SUBJECT: COOPER NUCLEAR STATION - STAFF ASSESSMENT OF INFORMATION PROVIDED PURSUANT TO TITLE 10 OF THE *CODE OF FEDERAL REGULATIONS* PART 50, SECTION 50.54(f), SEISMIC HAZARD REEVALUATIONS FOR RECOMMENDATION 2.1 OF THE NEAR-TERM TASK FORCE REVIEW OF INSIGHTS FROM THE FUKUSHIMA DAI-ICHI ACCIDENT (TAC NO. MF3734)

STAFF ASSESSMENT BY THE OFFICE OF NUCLEAR REACTOR REGULATION

RELATED TO SEISMIC HAZARD AND SCREENING REPORT

COOPER NUCLEAR STATION

Figure 3.3-1 Plot of Staff's and Licensee's Base Case Shear-Wave Velocity Profiles for the Cooper Nuclear Station site

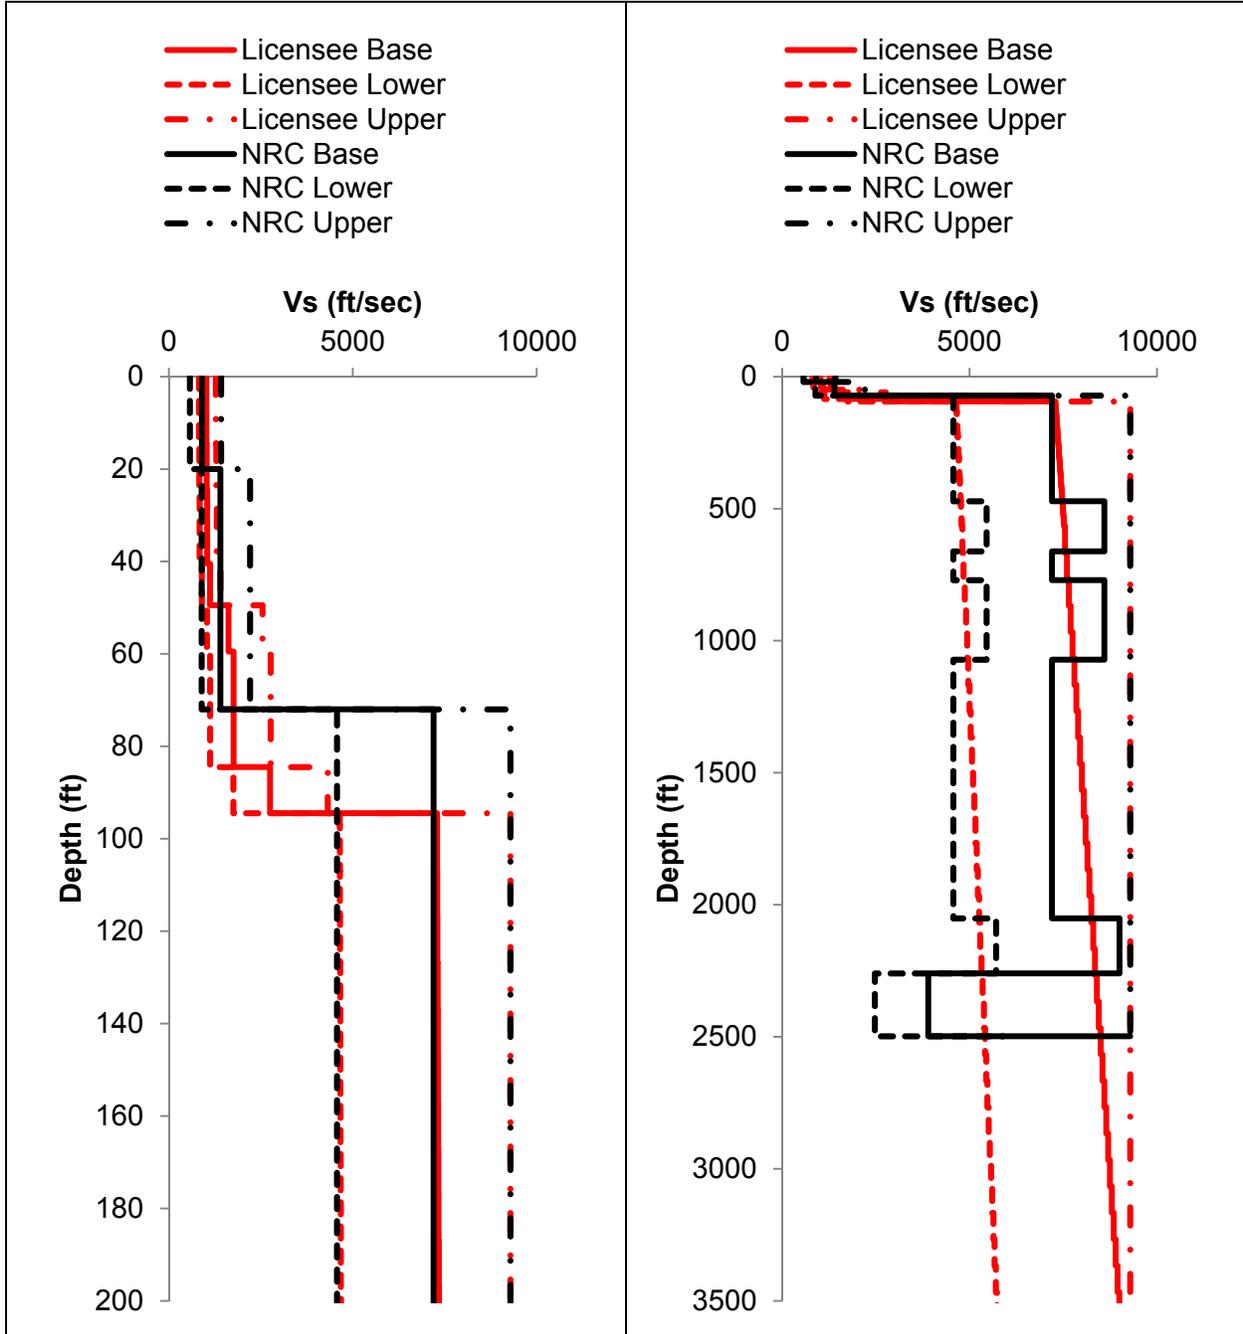
To characterize the subsurface geology, the licensee developed three site base case profiles. For the middle, or best estimate, profile, the licensee estimated a value of 7,292 ft/s [2,223 m/s] for the firm rock layers below a depth of 128 ft [39 m] based on the lithology of the rock. To develop the upper and lower base case profiles, the licensee used a scale factor of 1.25 for the upper 49.5 ft (15 m) and 1.57 below to reflect increased uncertainty for assumed shear wave velocities. Figure 3.3-1 of this assessment shows the licensee's three shear-wave velocity base case profiles.

To characterize the uncertainty in the subsurface material properties, the NRC staff developed three separate profiles. The NRC staff's shear wave velocity profiles are very similar to those submitted by the licensee in the upper 80 ft, but differ somewhat below 80 ft. The differences are due to the NRC staff's use of the shear wave velocities for similar rock units at other nuclear sites in the region while the licensee used a generic velocity profile from the SPID. The NRC staff's base case shear-wave velocity profiles along with the licensee's base case profiles are shown in Figure 3.3-1 of this assessment.

Figure 3.3-2 Plot Comparing the Staff's and the License's Median Amplification Functions and Uncertainties for two input loading levels for the Cooper Nuclear Station site

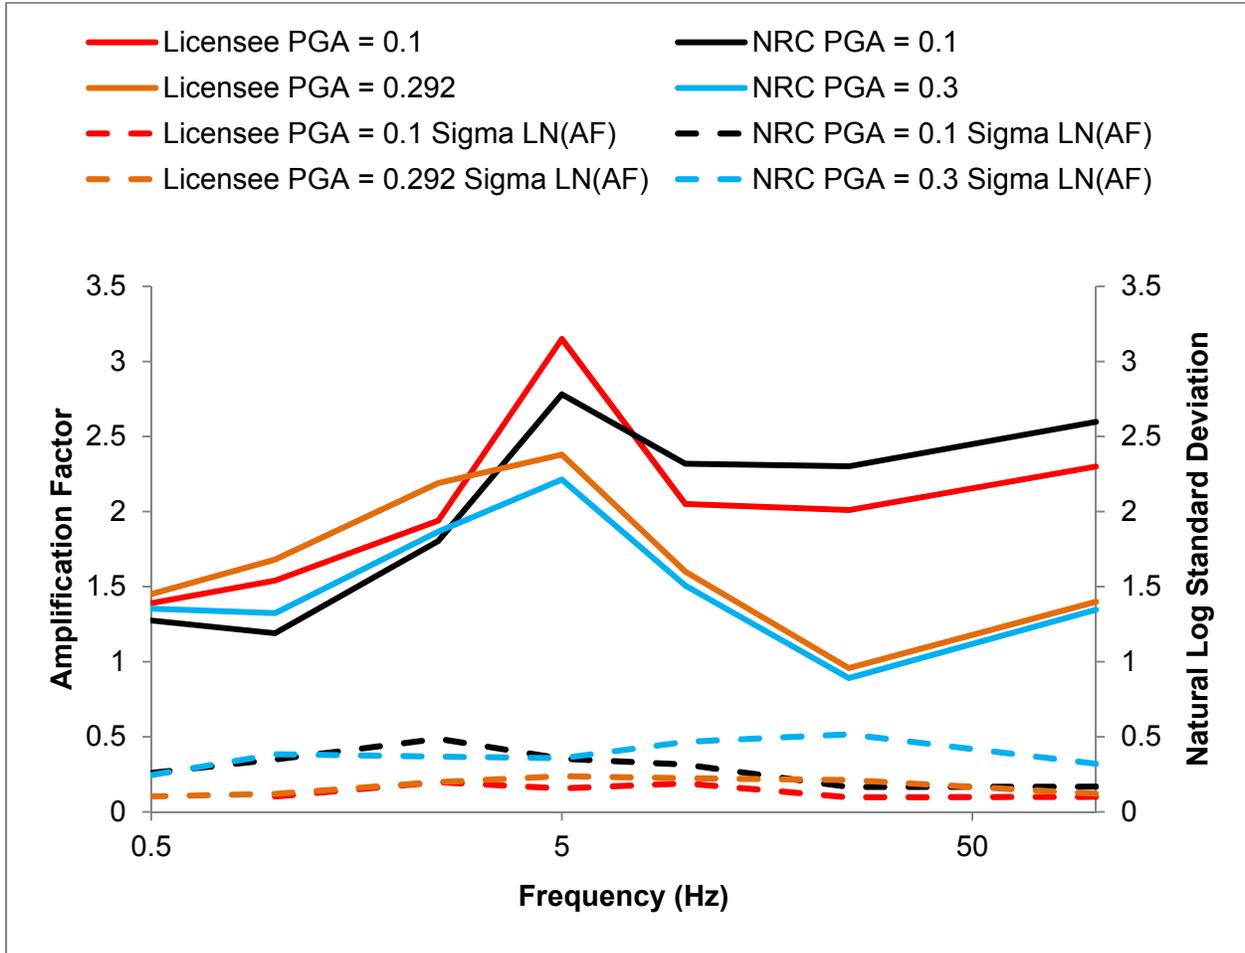
Figure 3.3-2 of this assessment shows a comparison of the NRC staff's and licensee's median site amplification functions and uncertainties for two of the eleven input loading levels for profiles used in the licensee's SHSR submittal. As shown in Figure 3.3-2, the differences between the NRC staff's and licensee's amplification functions and uncertainties are very minor. Figure 3.3-3 of this assessment compares the control point hazard curves at 1 Hz, 10 Hz, and PGA developed by the NRC staff with those developed by the licensee in its SHSR. Again the licensee's and NRC staff's control point hazard curves are very similar. These small differences in the site response analysis do not have a large impact on the control point seismic hazard curves or the resulting GMRS, as discussed below.
